Montgomery County Historic Preservation

Staff Report

<p>ADDRESS: 17 W. Irving St., Chevy Chase</p> <p>RESOURCE: Chevy Chase Village Historic District</p> <p>APPLICANT: Ed and Carolyn Nordberg (Luke Olson, Architect)</p> <p>REVIEW: HAWP</p> <p>CASE NO.: 1064778 REVISION #4</p> <p>PROPOSAL: Grading alterations, patio alterations, and new HVAC equipment</p>	<p>MEETING DATE: 5/27/2026</p> <p>REPORT DATE: 5/20/2026</p> <p>PUBLIC NOTICE: 5/13/2026</p> <p>TAX CREDIT ELIGIBLE: No</p> <p>STAFF: Devon Murtha</p>
---	---

Figure 4: Precedent image for screening around new condenser units.

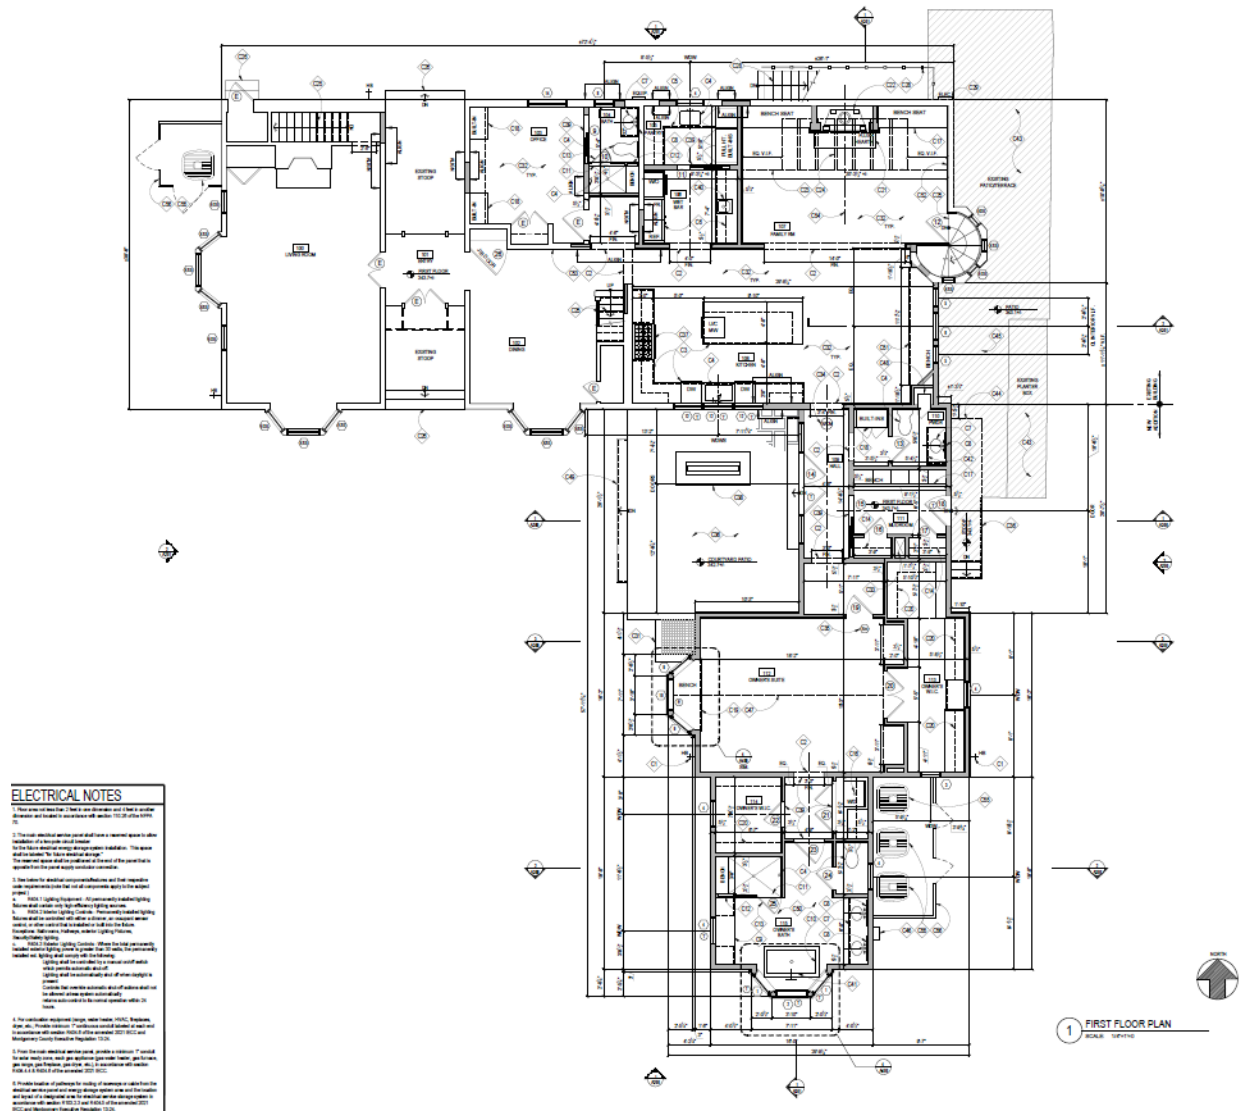
Finally, during the construction document phase, mechanical coordination has confirmed that the addition will require a [four] new condenser unit[s] and HVAC system. Due to property setbacks and the existing house orientation, the proposed location seems most appropriate and least conspicuous.

Staff finds that the applicant has successfully satisfied the conditions of approval from the last HAWP revisions that they must draw and label all features on the elevations and site plan, including the patio, driveway, and stairs along the right-side elevation. The applicant must submit complete specifications for all exterior features prior to issuance of approval documents, including specifications for the proposed condenser unit, material specifications for the condenser unit screening, and manufacturer specifications for the painted PVC boards.

Figure 5: First floor plan.

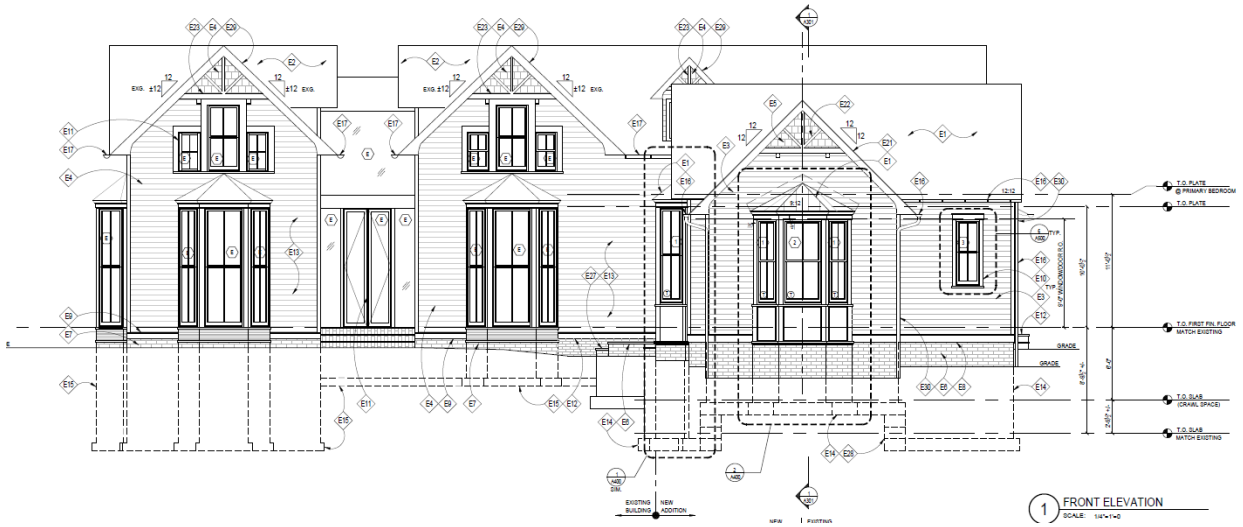
After further coordination with the builder and evaluation of existing site conditions, we have determined that the current side patio configuration is not optimal for drainage, as it is presently set at the same elevation as the first floor. To address this, we are proposing to lower the patio approximately 6 inches to bring it closer to grade and promote positive drainage away from the house. This modification is a replacement in kind intended to improve existing conditions.

Lowering the patio also provides an opportunity to better integrate the proposed side mudroom entry and improve circulation between the mudroom and the rear patio, while preserving the existing planter bed and mature trees.

The side stoop and steps have been revised to comply with setback requirements and to more seamlessly connect to the adjusted patio elevation, again minimizing disturbance to the existing landscape elements.

Figure 6: Proposed front elevation, showing grading changes and patio alterations.

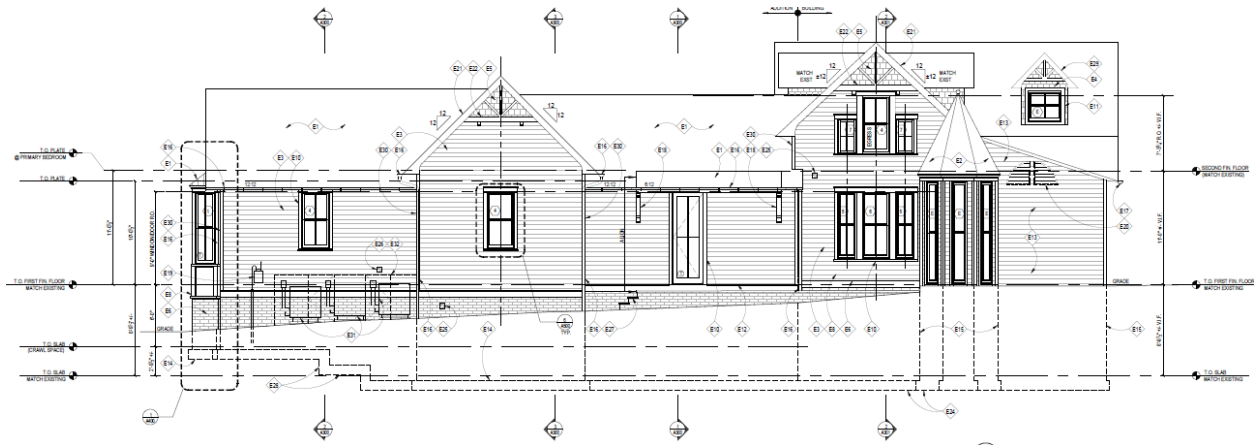
As construction details for the proposed hardscape courtyard have been further developed, we are recommending lowering the courtyard an additional step (approximately 7 inches). This adjustment improves drainage performance and avoids conditions where concrete would be in direct contact with wood or finished materials.

Staff finds that several of the alterations will be visible from the right-of-way at certain angles, but are generally compatible with the resource and the district, per Chapter 24-8A(b)(2).

Figure 8: Proposed rear elevation.

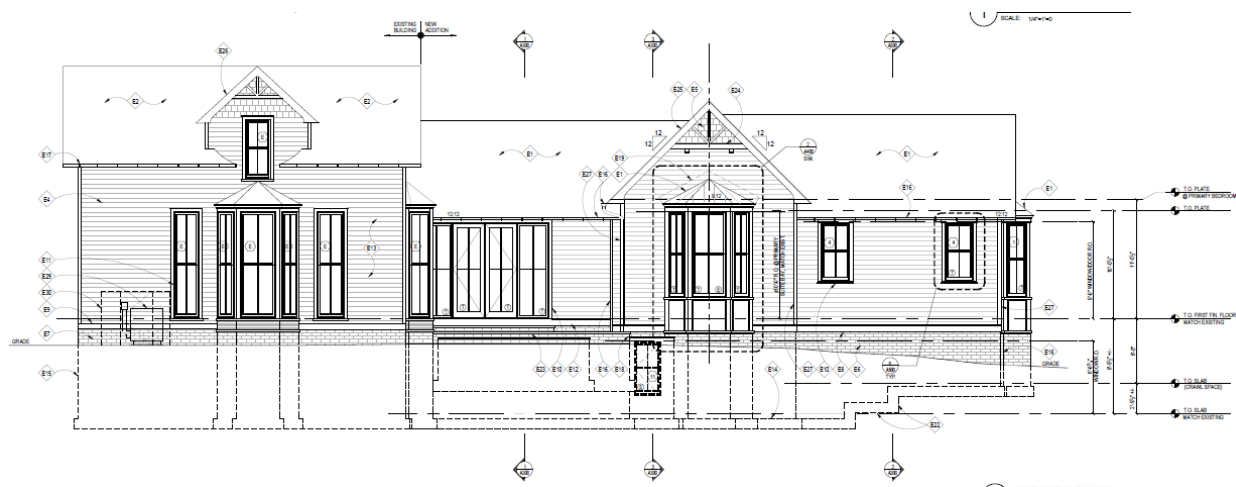
As we approach construction and continue evaluating the existing conditions, we identified a rear window that requires replacement. The drawings have been updated to clearly distinguish between existing windows to remain and those to be replaced.
